Application under the Agricultural Operation Practices Act for a confined feeding operation, manure collection area, and/or manure storage facility(ies)

<b>NRCB USE ONLY</b>	Application number <b>LA24032</b>	Legal land description <b>SW 32-8-24 W4M</b>
<input checked="" type="checkbox"/> Approval <input type="checkbox"/> Registration <input type="checkbox"/> Authorization <input type="checkbox"/> Amendment

**Re:                   Geotechnical Review and Evaluation  
                      NRCB Permitting of Proposed Catch Basins  
                      SW-32-008-24-W4M, near Fort Macleod, Alberta**

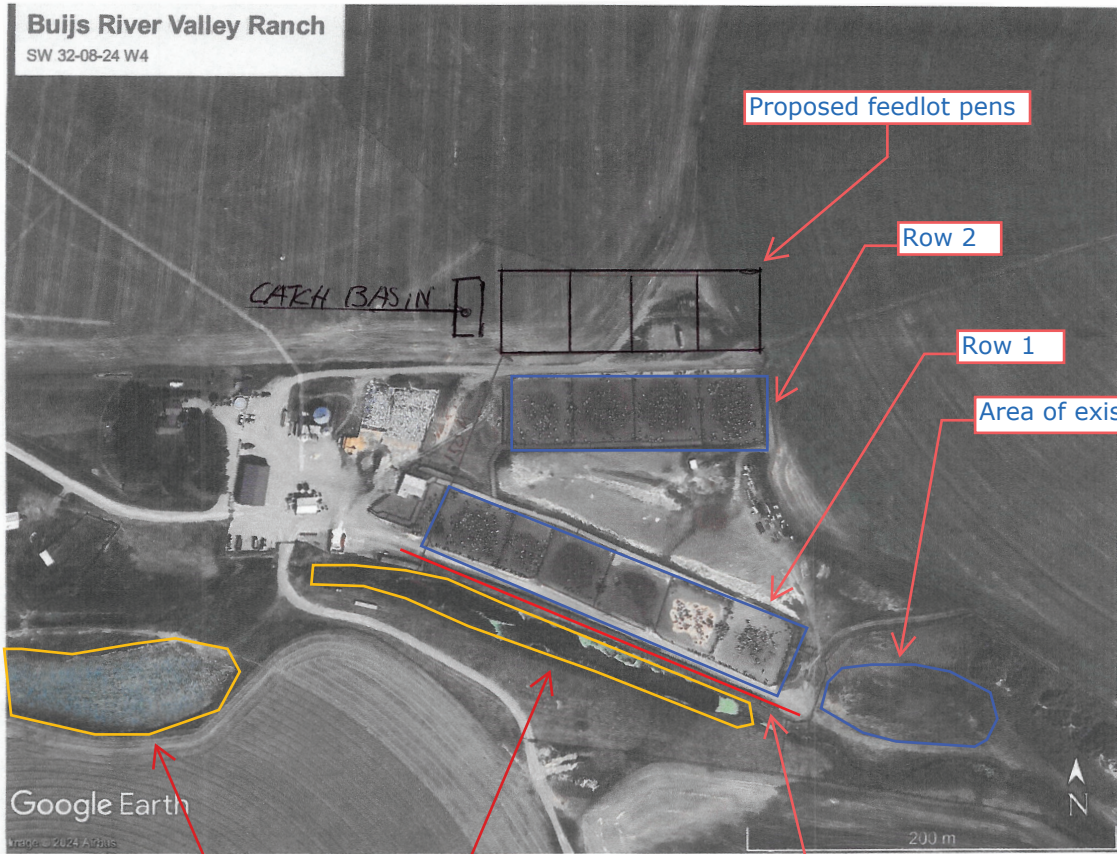
AO Comment: The applicant is applying for a naturally occurring protective layer to meet AOPA's groundwater protection requirements for the new feedlot pens. The applicant has indicated they may install roller compacted concrete (RCC) as a secondary liner in the new feedlot pens in the future. Because RCC is known to increase run-off volume, the new proposed catch basin is designed to meet the requirements for a paved run-off area.

# Catch Basin Storage Volume Calculator

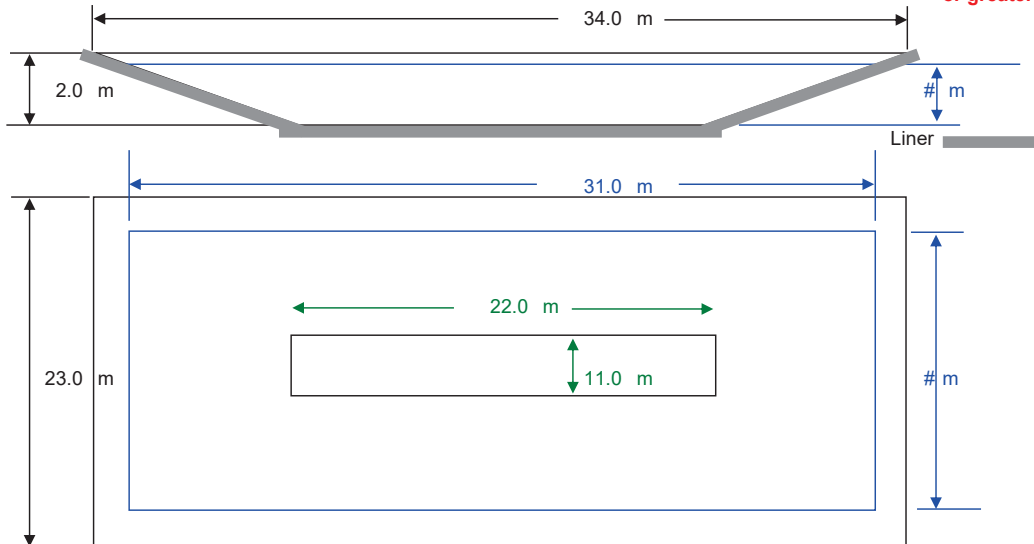
AO Comment: Initial proposed dimensions of new catch basin did not meet AOPA 9 month storage requirements for run-off. Applicant has proposed new dimensions to meet AOPA requirements.
